LIGO Laboratory / LIGO Scientific Collaboration

BSC-ISI Update – Release Notes

Version 2

LIGO-T1600062

Fig. 5: 4.a. after

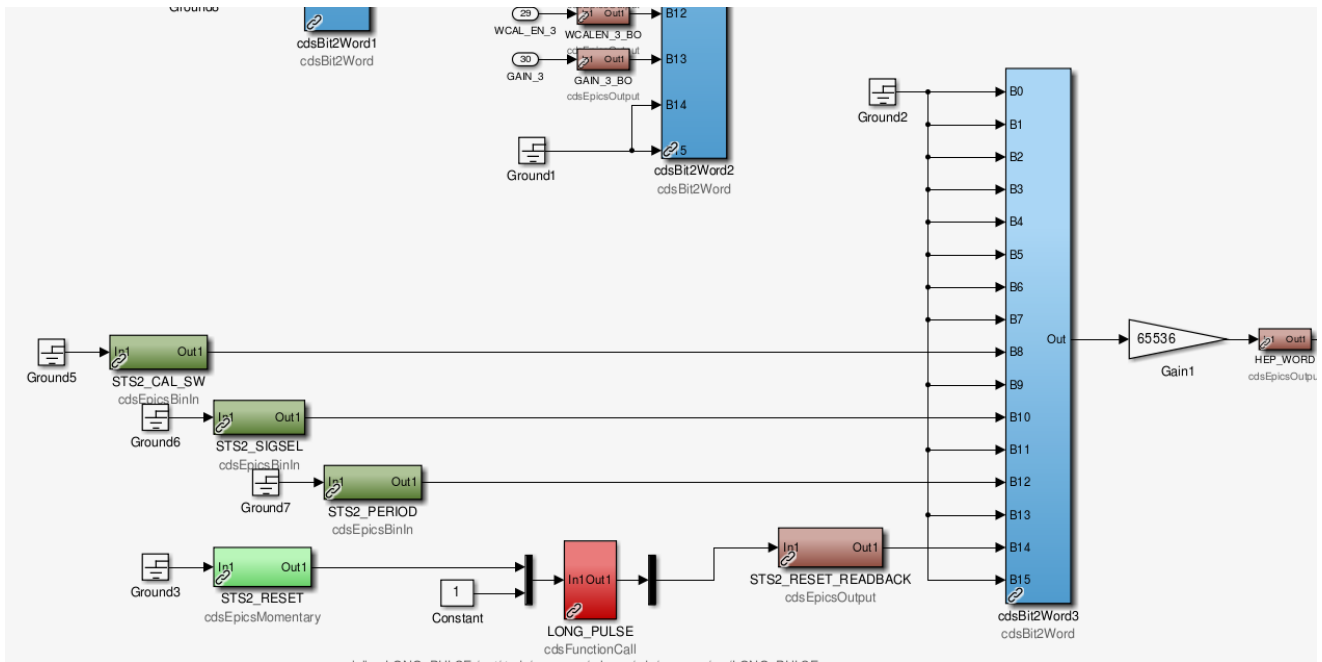
a) fix low case names of the STS-2 commands in the BIO_OUT block for the isi2stagemaster.mdl

Fig. 7: 4.b After

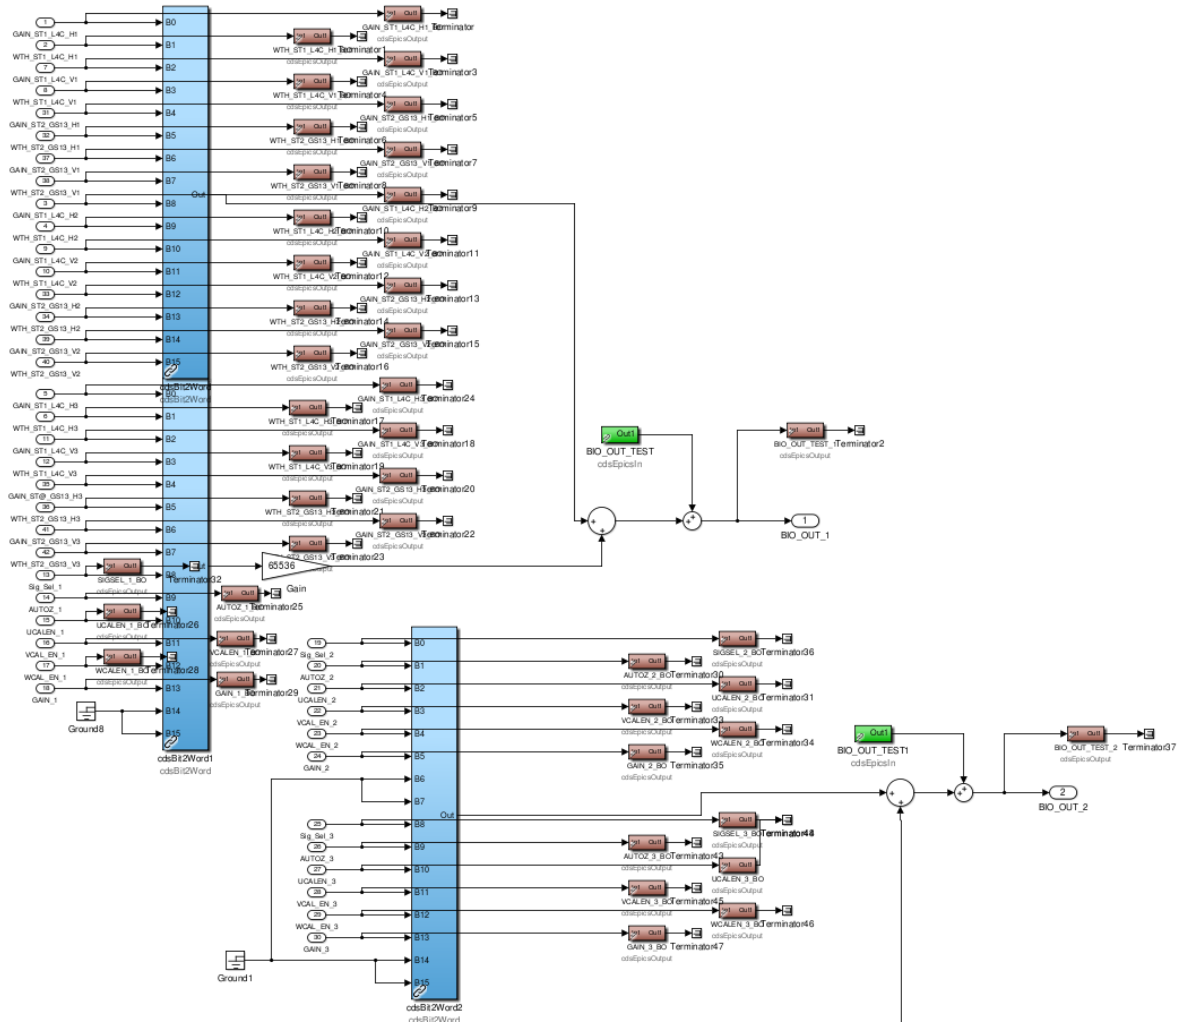
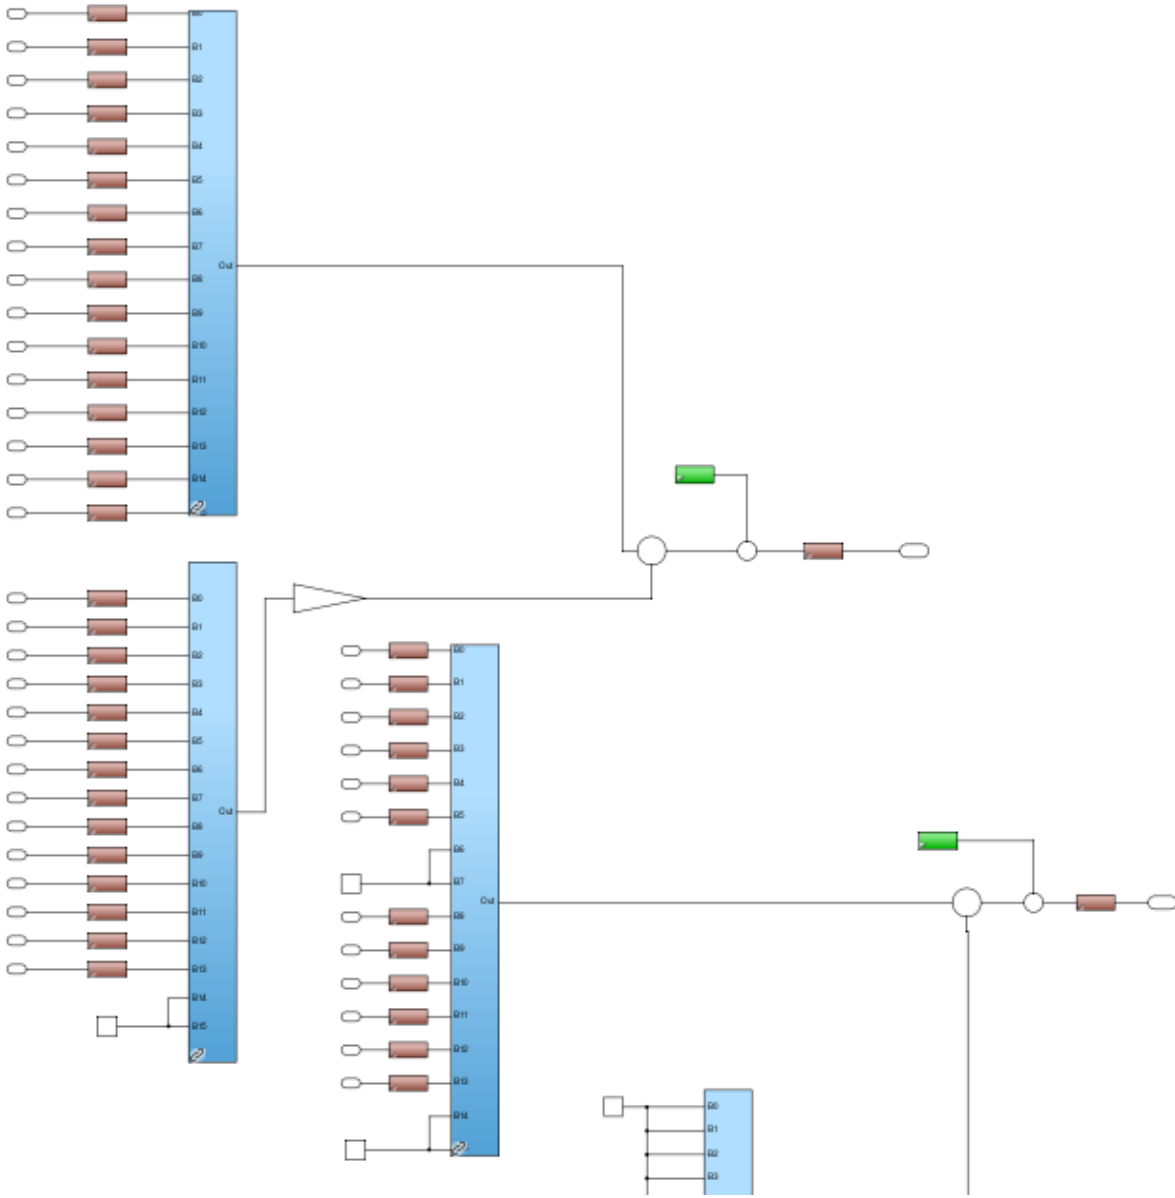
b) clean up BIO_OUT block content

Fig. 8: ST1 updated (item 8)

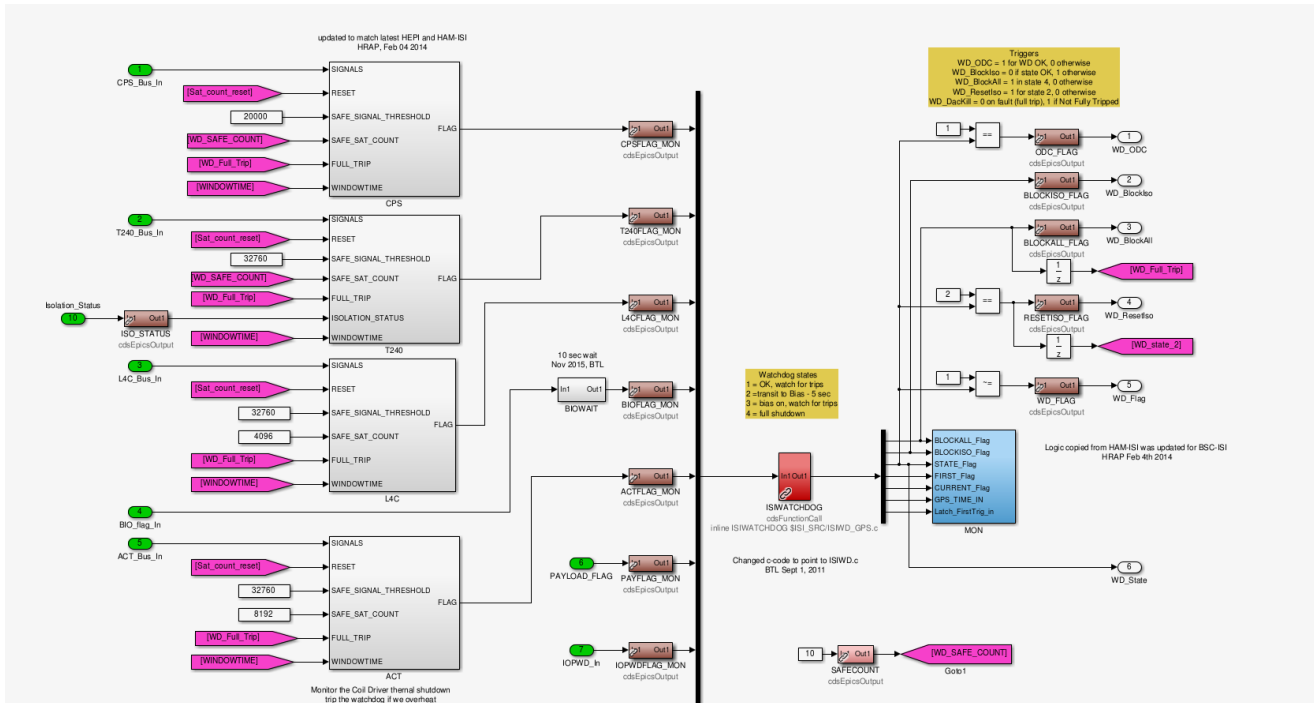
8) increase number of allowed saturations for BSC-ISI WDs

Fig. 11: BSC-ISI model updated with SATURATIONS_SINCE_RESTART

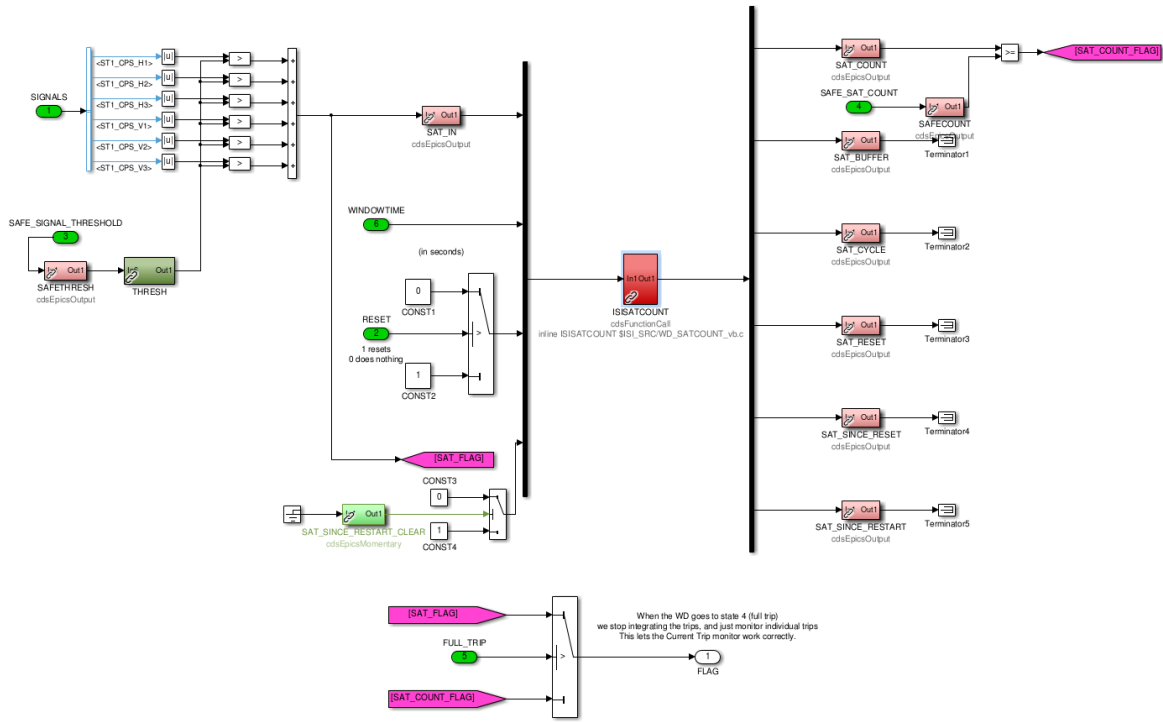
9) add "saturations since model start" epics channel to SEI watchdogs
https://services.ligo-wa.caltech.edu/integrationissues/show_bug.cgi?id=1134

**a new version of WD_SATCOUNT.c was created to prevent from impacting the HAM-
ISIs which have not received the model update yet: WD_SATCOUNT_vb.c**

Fig. 13: BSC=ISI BIO Out updated

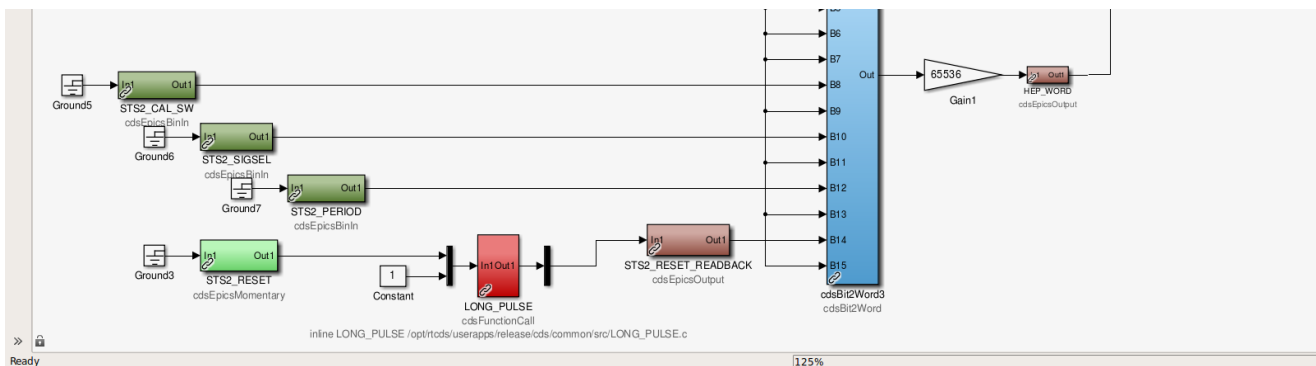
12) BIO Out – largely redundant with item 4.

b) we'd like to upgrade the reset momentary to use the

c-code where the duration of the pulse is user-defined such that it can send out the desire ~0.5 [sec] voltage pulse. (This is presumably what the additive STS2_Reset_ADD was trying to do).

c) All of the cdsEpicsIn parts need to have their channel names capitalized in order to be functional.

d) The CAL, SIGSEL, and PERIOD should be changed to epicsBinIns, such that they can appear as rocker switches in MEMD just like they do on the front panels.

Model updated. Hugh updates MEMD screens (ISI_CUST_CHAMBER_BIO). The correct setting for the new epics bin is 0. See SEI aLog 903 which shows what they were before at LHO.

Fig 14: Library blocks

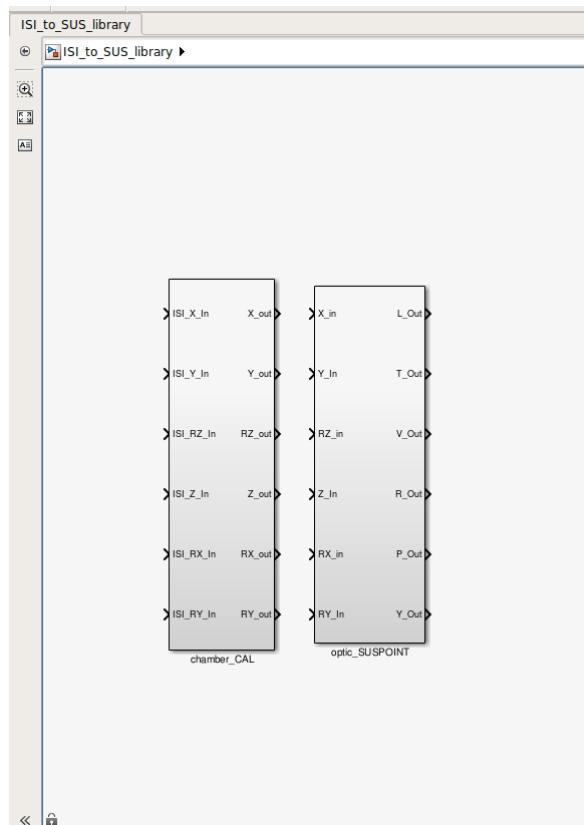
13) create ISI to SUS point library block to be placed on the top level model

library can be found under: /opt/rtdcs/userapps/release/isi/common/models/ISI_to_SUS_library.mdl

Parts should be copied from the library into the top-level model of each BSC-ISI. The “chamber” and “optics” portion of the library blocks should be updated to the relevant upper case entries.

For the moment, leave the inter-model communications as they are. Once the Detchar pages showing system performance have been pointed to the new channels, we can remove the GS-13 communications to the SUS model, and also remove those calculations from the SUS model. The filters and matrix should be copied from the appropriate SUS model. The filters need to be checked because the model rates are different.

Fig 17: BSC-ISI - ST2 SENSOR SCSUM added (item 14)

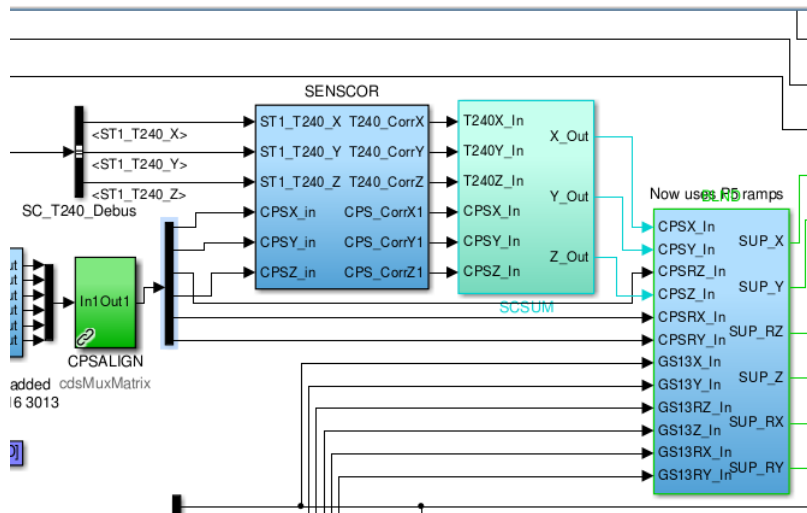
a) Add an SCSUM block after the ST2, SENS COR block, just like what is in place for the GND to ST1 sensor correction in the ST1 block

b) Store the new sensor correction channels
